Amendments to the Drawings:

Two sheets of replacement drawings are attached. As with the original drawings, one sheet includes Figures 3A-3B, and one sheet includes Figures 4A-4C. In the replacement sheets, handwritten content has been replaced with professional artwork for Figures 4A-4C.

FIG. 3A

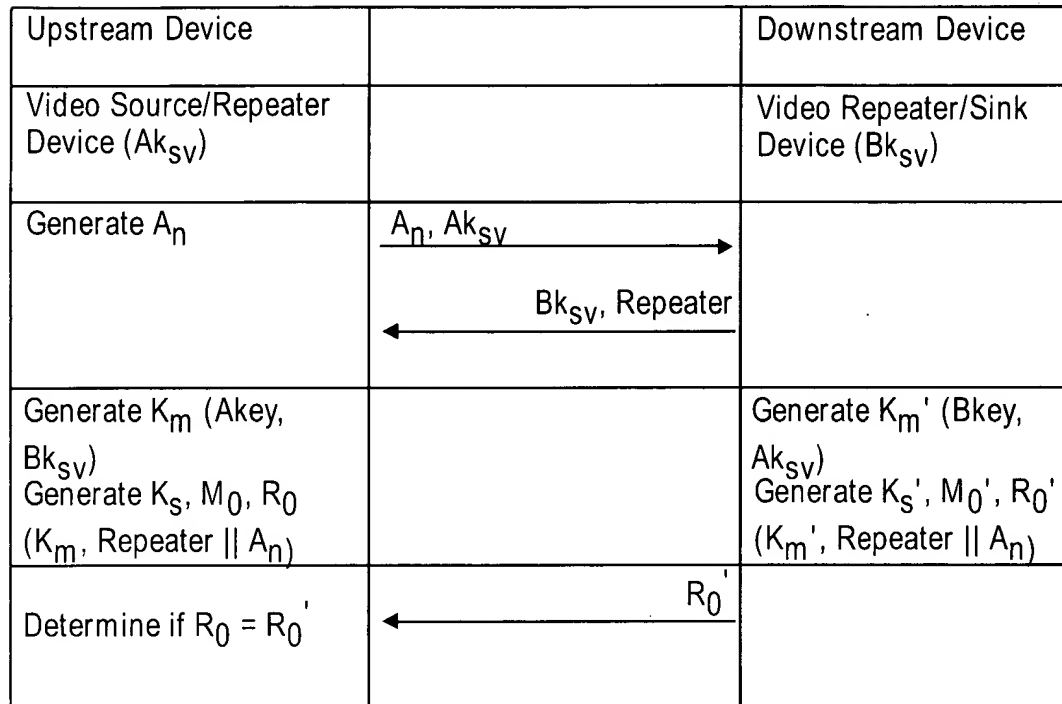
In Figure 3A, the following corrections have been made to the fourth row of the table, in accordance with the Detailed Description:

- the underlining has been removed from “Akey” and “Bkey,”
- the stricken-through subscript “sv” in column one had been deleted, and
- the stricken-through term “Bk_{sv}” in column three has been deleted.
